**DENDROBIUM AREA 3C  
LONGWALLS 22 & 23 SUBSIDENCE MANAGEMENT PLAN  
Reasons for Approval**

**SMP APPLICATION**

- South32 applied for approval of a SMP for Area 3C LWs 22 and 23 on 8 September 2021.
- In addition to the SMP itself, conditions of consent require that the SMP integrates two other more detailed plans, including a Watercourse Impact Monitoring, Management and Contingency Plan (WIMMCP) and a Swamp Impact Monitoring, Management and Contingency Plan (SIMMCP). Each of these plans also contains a Trigger, Action, Response Plan (TARP). Most of the detailed monitoring, management, remediation and contingency measures applicable under the SMP are contained within the WIMMCP and SIMMCP and their associated TARPs. The WIMMCP and SIMMCP contained in the LWs 22 and 23 SMP apply to mining in all of Area 3C.

Figure 1: Proposed Longwalls 22 and 23 in Area 3C

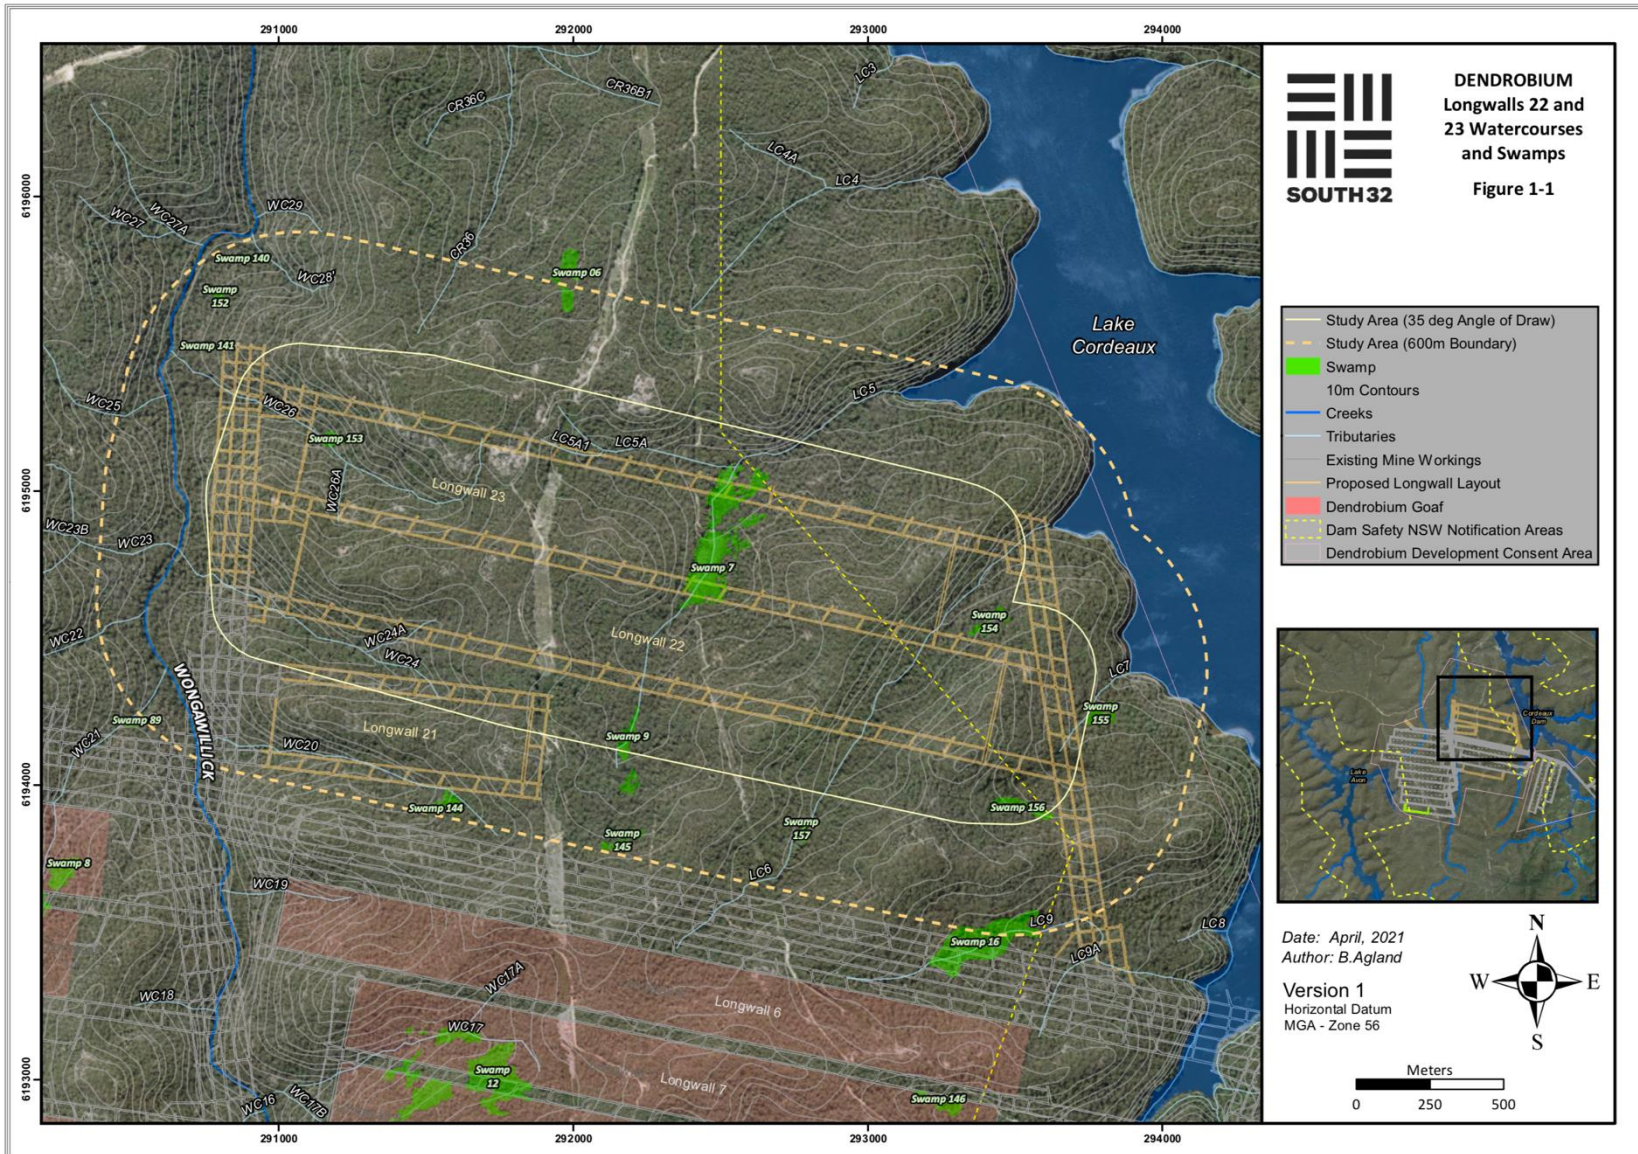
- WaterNSW and BSC recommended mine design changes to minimise or avoid subsidence-related impacts to swamps (Swamp 7) and tributaries (LC5 and LC6) located directly above the proposed LWs 22 and 23. The agencies suggested greater setbacks, narrower longwalls, shorter longwalls and/or the adoption of different mining methods (i.e. bord and pillar).

- Two swamps (Swamps 7 and 153) are located directly above the proposed LWs 22 and 23 (see **Figure 1**). An additional four swamps (Swamps 9, 154, 155 and 156) are located wholly or partially within the 35° angle of draw line. The largest and most significant of these swamps is Swamp 7 which is located directly over Longwall 23 and covers an area of 4.9 hectares (ha).

- The Panel therefore concluded that it "*has no reason for suggesting that the dimensions of LW22 & 23 should be reduced for the purpose of managing impacts on LC5, LC6 and Swamp 7.*"

- The Department agrees with this conclusion.
